# PHAP13-00015

Date:	August 5, 2013
Application Type:	Certificate of Appropriateness
Property Owner:	Carlos and Yadira Rubio
Representative:	Jose Lozano
Legal Description:	Being 10 Sunset Heights 30 & W 1/2 of 29, Texas, El Paso County, Texas.
Historic District:	Sunset Heights
Location:	620 Prospect Street
Representative District:	#8
Existing Zoning:	A-2/H (Apartments/Historic)
Year Built:	1921
Historic Status:	Contributing
Request:	Certificate of Appropriateness for the replacement of sash, wood, multi-light windows with fixed metal windows after-the-fact.
Application Filed:	07/24/2013
45 Day Expiration:	09/07/2013

Certificate of Appropriateness for the replacement of sash, wood, multi-light windows with fixed metal windows after-the-fact.

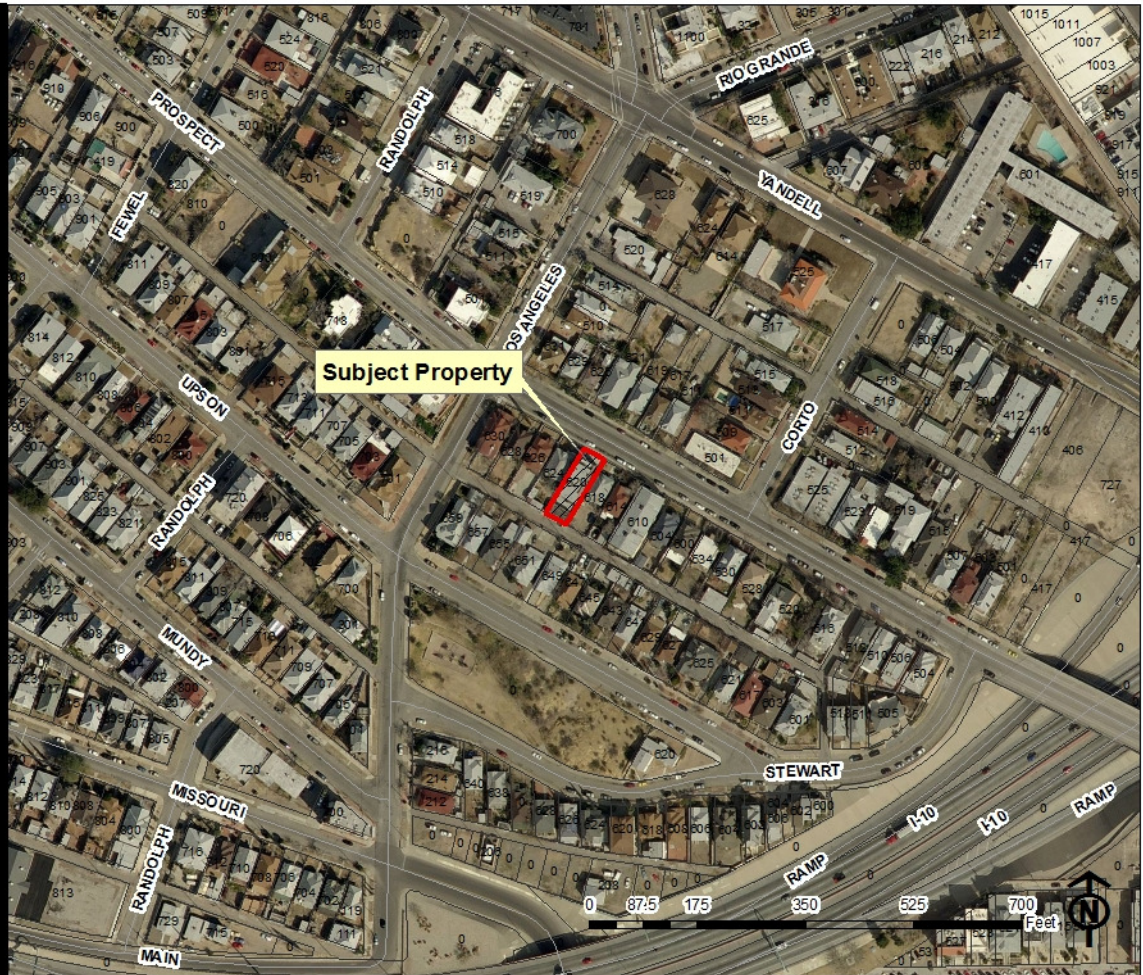
- The Historic Preservation Office recommends DENIAL of the proposed scope of work based on the following recommendations:

- *If windows are damaged beyond repair, replacement windows should match the type (such as double hung), style (for example six panes over six panes), and finish (paint).*
- *Replacement windows on the main façade shall be comprised of the operable portions of the window and match the type, style, operation, configuration and finish of the original windows.*
- *Do not use single pane picture windows or horizontal sliding windows if they are not the original window types.*
- *Installation of windows similar to the original in appearance and structural purpose, regardless of construction materials is permitted.*
